**[ Union of  
Concerned Scientists**

## **Status of Fukushima Lessons**

**July 31, 2014**

**Director, Nuclear Safety Project**

February 2013 FLEX Integrated Plan

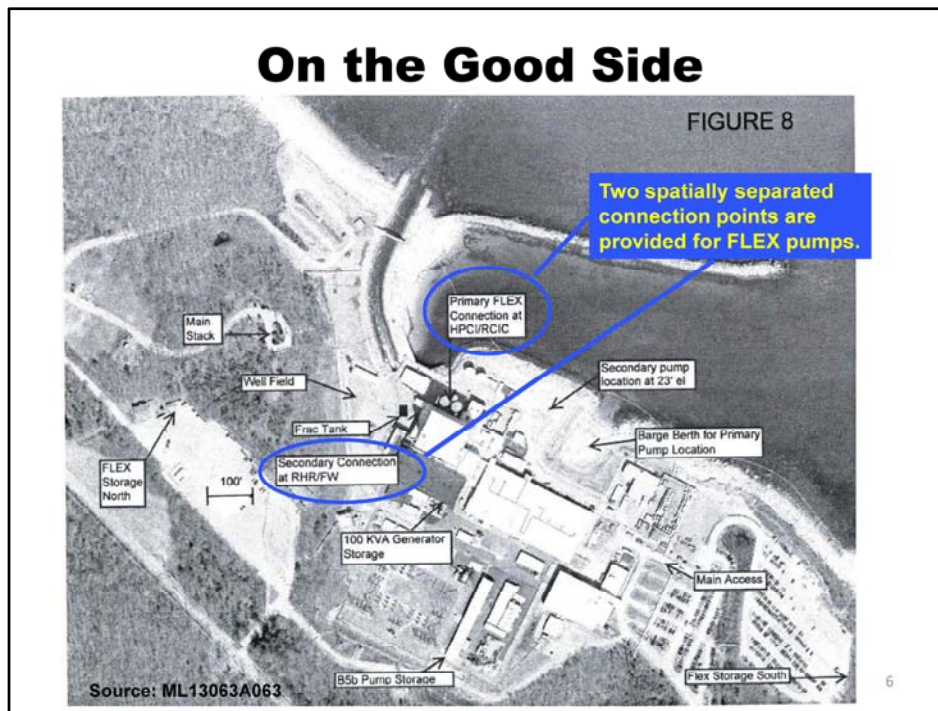
**In general, FLEX provides at least N+1 widgets or connections when N is required for success.**

**A potential strength of FLEX is in providing at least N+1 options when N is required for success.**

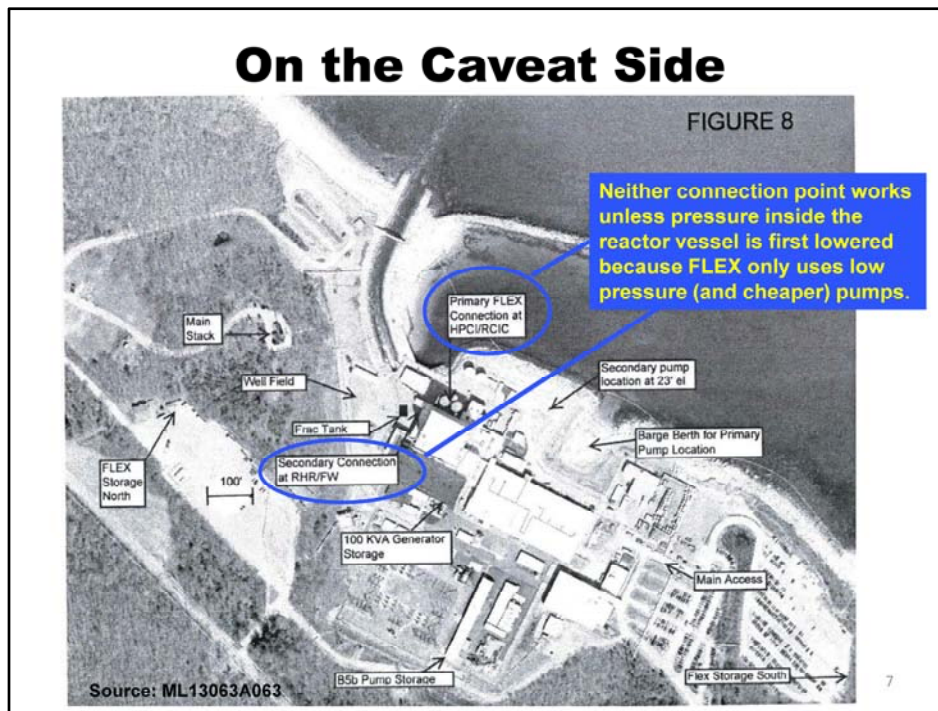
**This map of the Pilgrim site shows that multiple points are envisioned for connecting FLEX's makeup pumps.**

But even a dozen connections could be useless because none of the FLEX pumps can provide high pressure makeup. The reactor pressure must be reduced by non-FLEX methods for FLEX's teeny tiny pumps to work.

February 2013 FLEX Integrated Plan

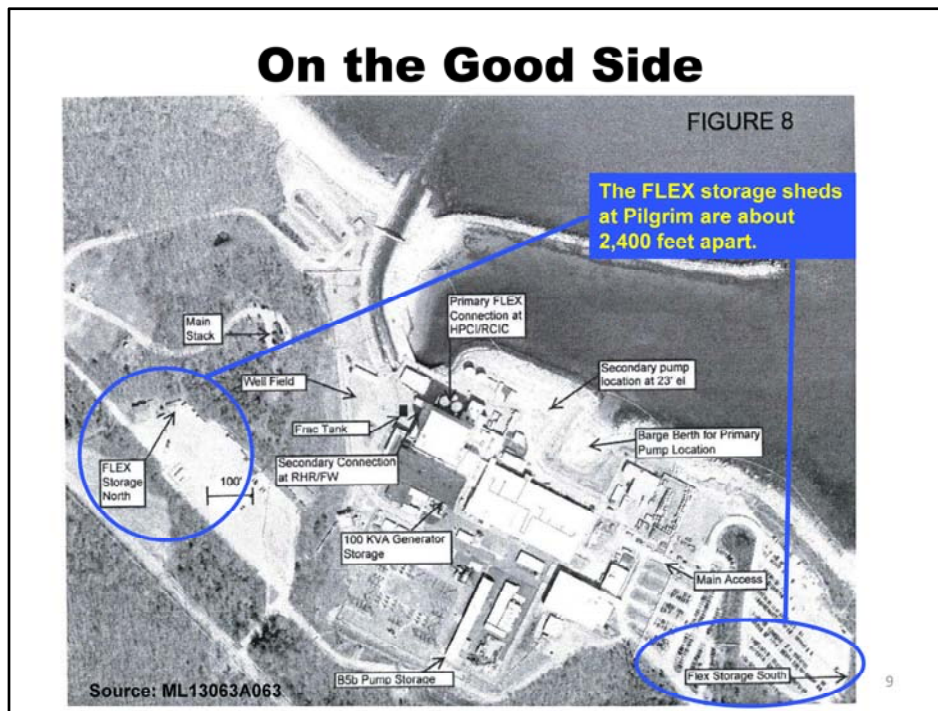
**0 < N and  
nature rather  
than the NRC's  
assessment  
determines the  
outcome.**

**Entergy's analysis for Pilgrim shows that a tornado could disable all of the FLEX equipment. Having more equipment that workers cannot use is not the proper goal here.**

# Pilgrim's BDBEE Plan

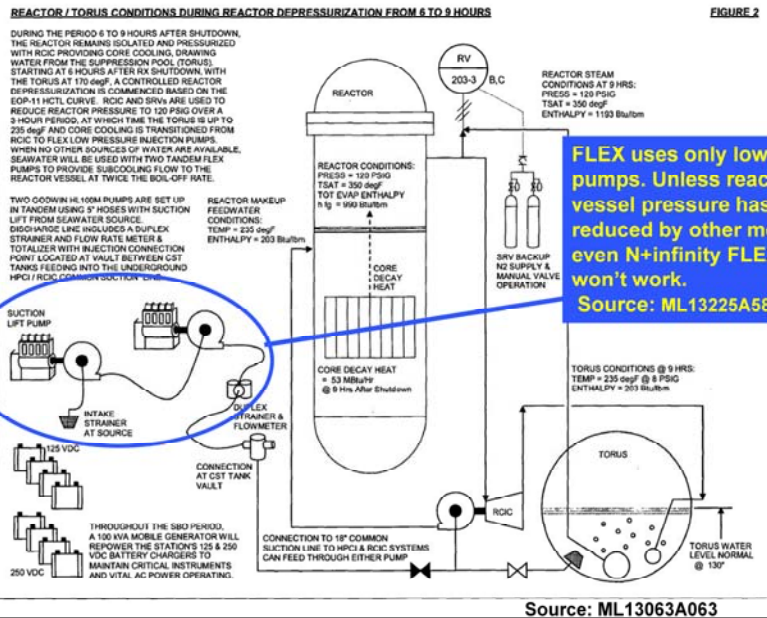
**FLEX uses only low pressure pumps. Unless reactor vessel pressure has been reduced by other means, even N+infinity FLEX pumps won't work.**  
Source: ML13225A587
